Department of Community Development Staff Report

APPLICANT: Bealeton Solar, LLC

MEETING DATE: November 21, 2024

REQUEST: SPEX-24-023123 – Bealeton Solar Center: An application for a Category 20 Special Exception to allow a Utility Scale Solar Electrical Generating Facility.

Concept Plan

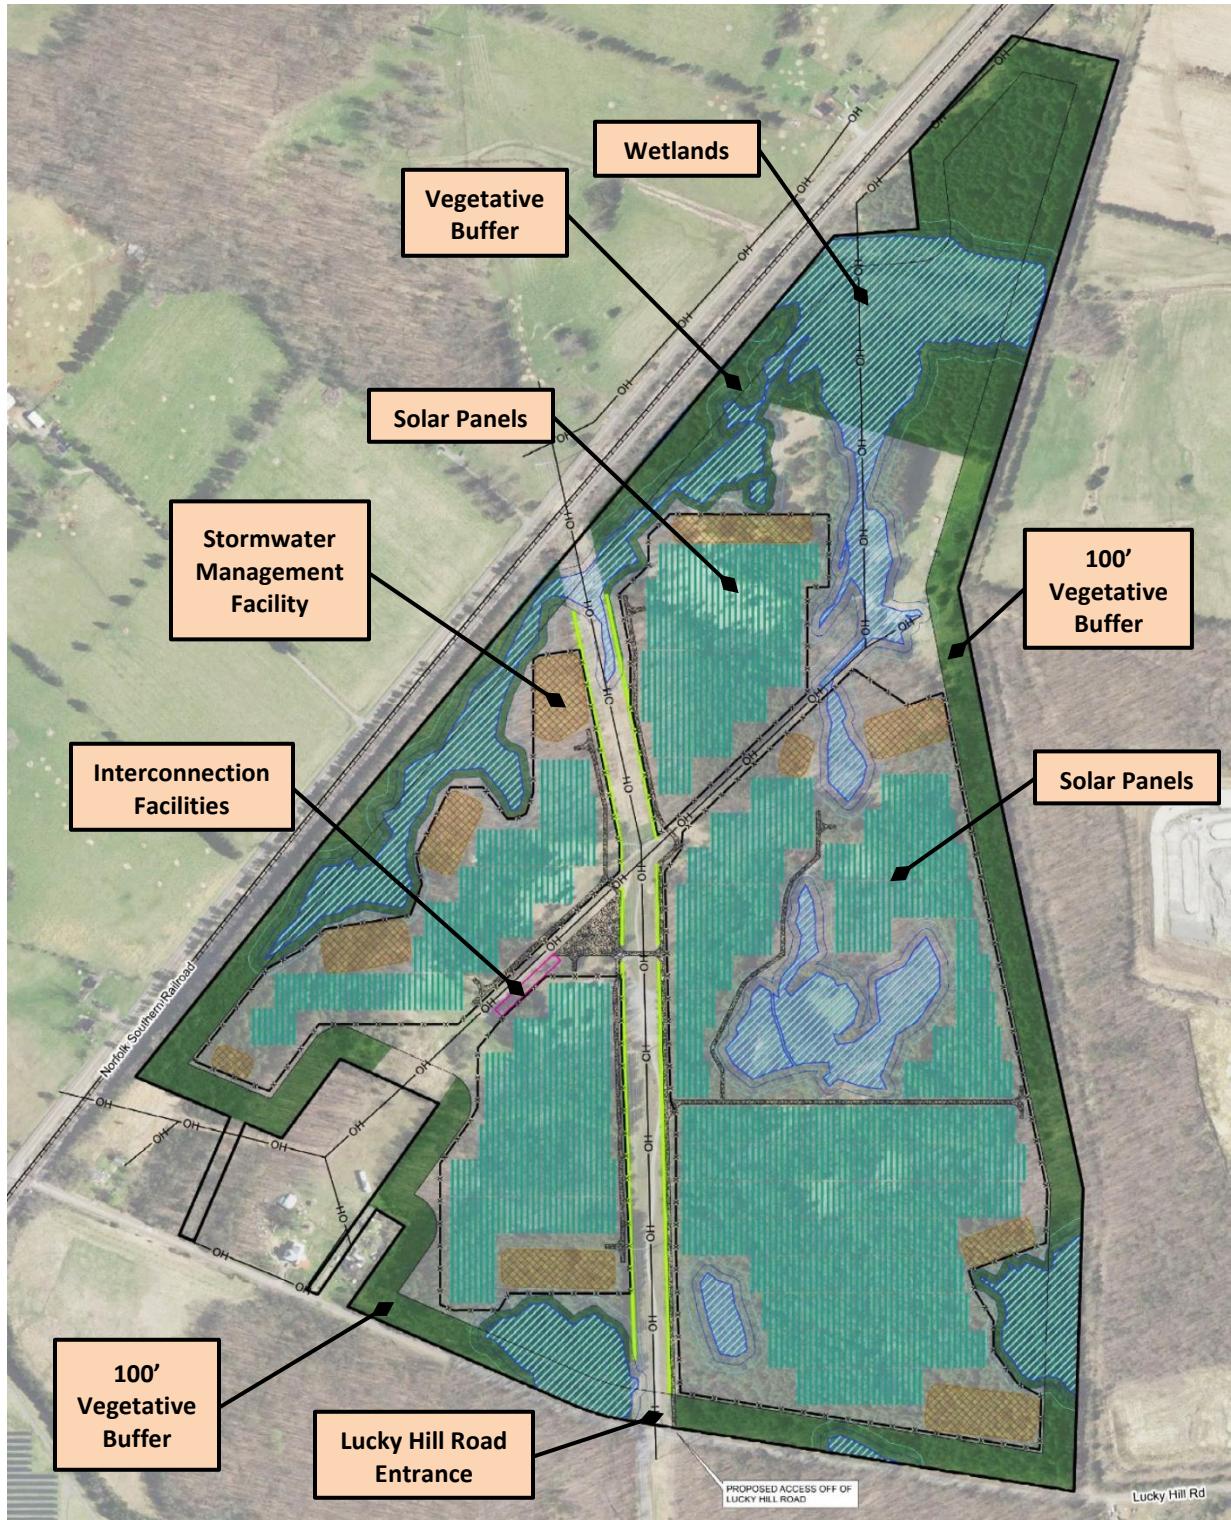
4. The project consists of five (5) separate parcels. The parcel lines are not shown on Sheet P103 Conceptual Site Plan. It appears panels have been placed over the internal lot lines. Either the internal lots must be vacated or the panels re-arranged to meet the minimum setback required by the RA district of 25' between parcels pursuant to ZO Section 5-2003.7

6. Stormwater facilities have been shown on Sheet P103 Conceptual Development Plan; however, additional information, such as topographic information, soils or drainage divides, has not been provided to determine whether the plan is viable. Grading has not been shown to determine whether the limits of clearing impacts any of the environmental areas.

1. The proposed conceptual site plan shows 10 stormwater management facilities. There is no topography sheet in the plan set, so the location of the sites cannot be evaluated. It appears all 10 facilities are within the fence around the project. County access for inspection will be needed both during construction and post-construction. The post-construction inspection requirement at this time is once every three years. Owners are required to complete post – construction inspections annually.

Staff has included a condition which addresses this comment.

Staff has included a condition which addresses this comment.
